Clarification of collision risk impact assessment approach for the European Offshore Wind Deployment Centre – Updated approach following changes to the Rochdale envelope.

Project/Job Title: **Aberdeen Windfarm**
Genesis Job Number: **J-90008/A**

Prepared for:
AOWFL

Figure 1 The survey areas covered by the AOWFL during 2007-2008 and 2010-2012 (reproduced from the Environmental Statement)

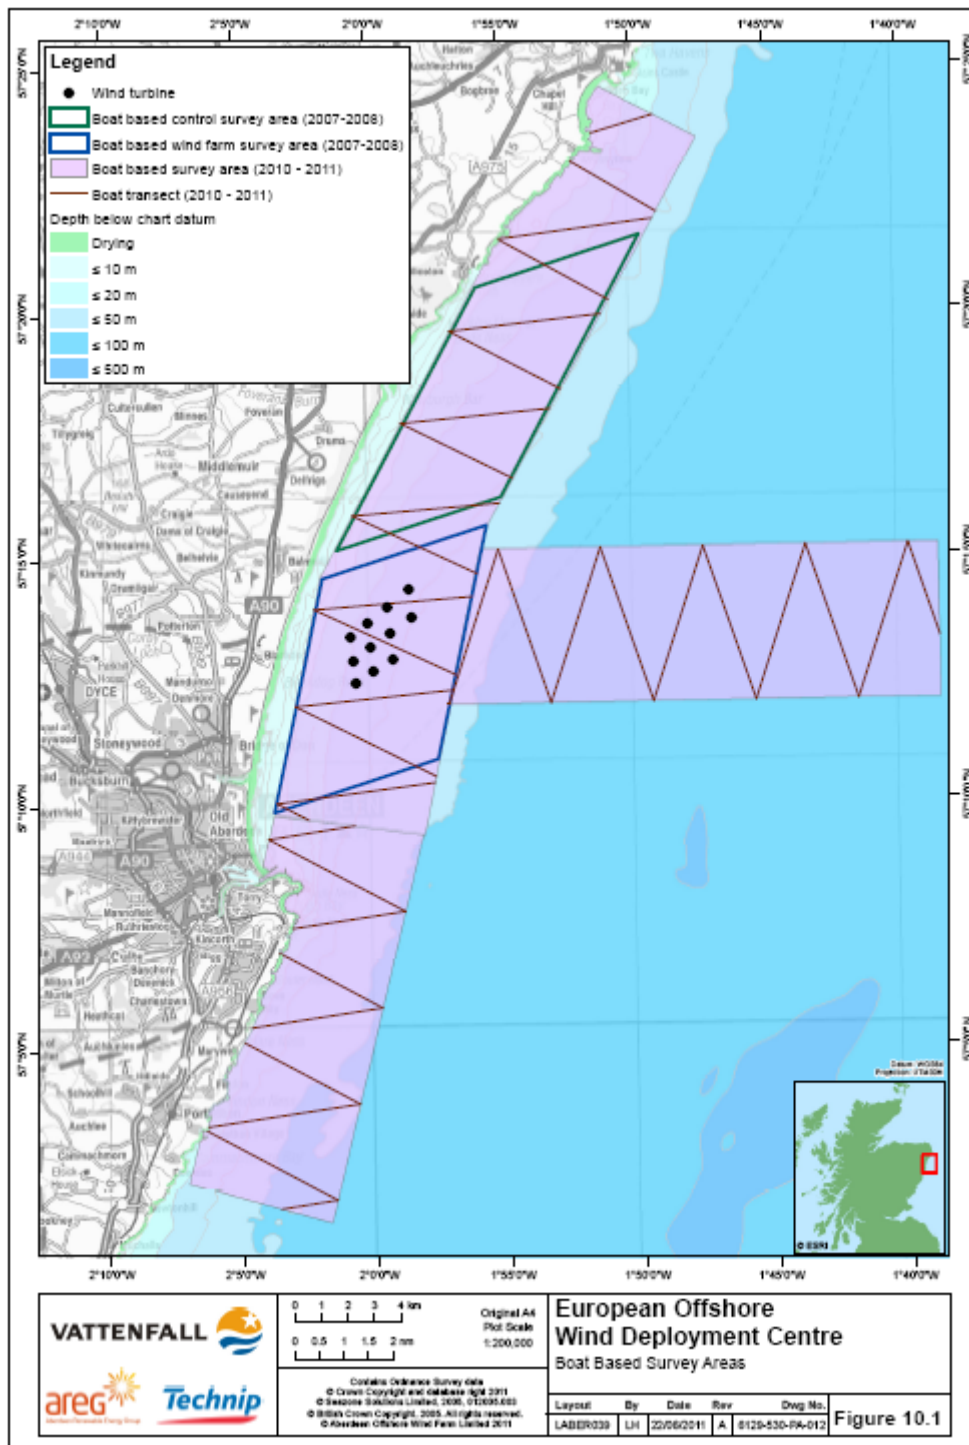
- blue illustrates successful survey, April 2008, June 2011, July 2011 and January 2012 have two surveys.
2. We take from the text that the reason why Year 2 data from only the “Northern” Transect area will be used is to make it more comparable with Year 1 data. The different scales of Figs 1 and 2 make it difficult to judge whether Year 1 and Year 2 data extend equally far north and we recommend that these scales be equalised in the ES addendum.

AOWFL response: Figure 1 illustrates the areas covered in during the two phases of AOWFL boat surveys. The survey area for the later boat based surveys extends marginally further north than the 2007-2008 surveys, but the majority of the survey area is comparable.
